NOTICE OF DENIAL

RE: Application Number 21-7586; 1713 Seyburn; West Village Historic District Project Scope: Replacement of Rear Entry Door

CERTIFICATE OF APPROPRIATENESS

RE: Application Number 21-7586; 1713 Seyburn, West Village Historic District

1713 SEYBURN

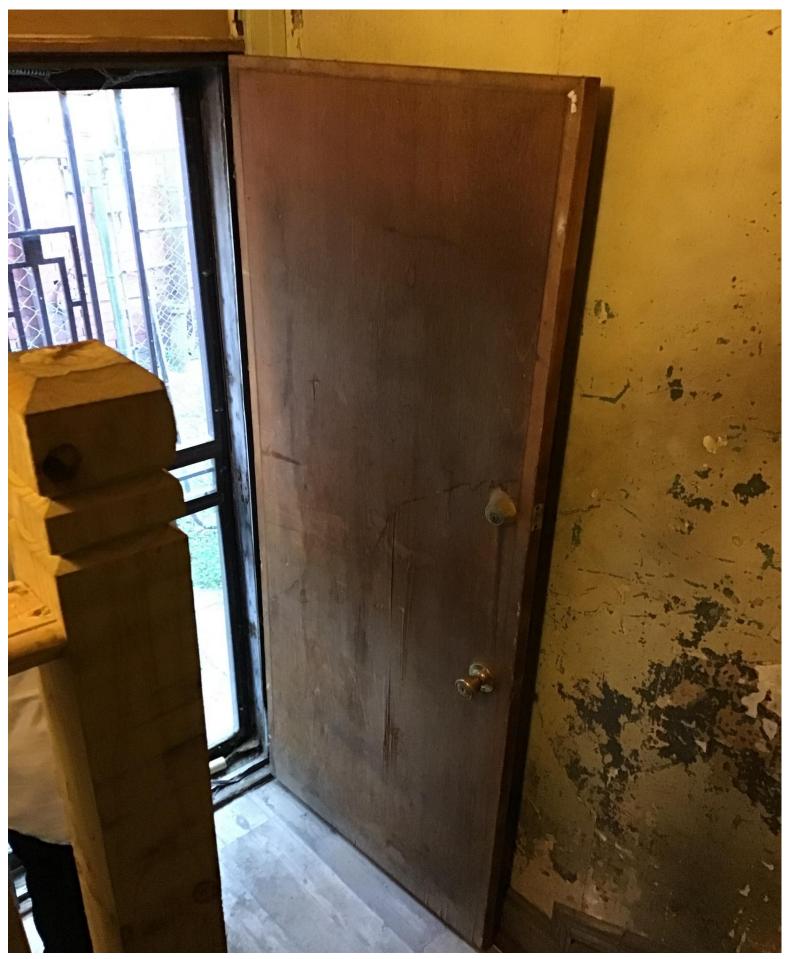
Replacement of Rear Wood French Doors with Solid Metal Double Doors (with small windows)

The reasons for the denial are a failure to meet the following specific Standards or Elements:

- <u>Standard 2:</u> The historic character of a property shall be retained and preserved. The removal of historic materials or alteration of features and spaces that characterize a property shall be avoided.

- <u>Standard 5</u>: Distinctive features, finishes, and construction techniques or examples of craftsmanship that characterize a property shall be preserved.

- <u>Standard 6:</u> Deteriorated historic features shall be repaired rather than replaced. Where the severity of deterioration requires replacement of a distinctive feature, the new feature shall match the old in design, color, texture, and other visual qualities and, where possible, materials. Replacement of missing features shall be substantiated by documentary, physical, or pictorial evidence.

- <u>Standard 9:</u> New additions, exterior alterations, or related new construction shall not destroy historic materials that characterize the property. The new work shall be differentiated from the old and shall be compatible with the massing, size, scale, and architectural features to protect the historic integrity of the property and its environment.

Replacement of Side Entry Wood Door

The COA was issued with the following conditions:

- The new door can be metal
- The design can be a solid panel design or a combination panel/glass design.
- A catalog cut of the selected door (confirming design, material and finish color) will be submitted for staff review.

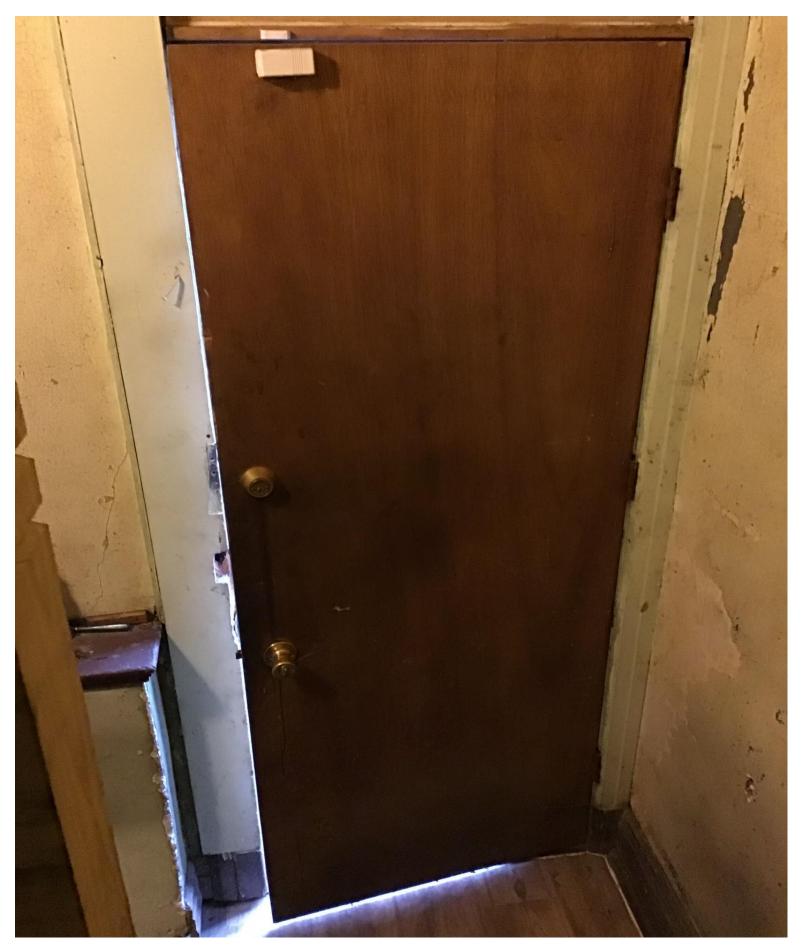
SIDE DOOR Looks like a Solid-wood interior door Door handle and dead bolt are not spaced normal

SIDE DOOR
Looks like a Solid-wood interior door
Door handle and dead bolt are not spaced normal
You can see where dead bolt should be located on a normal entry door in this picture

BACK DOOR No door knobs, not a "real" entry door
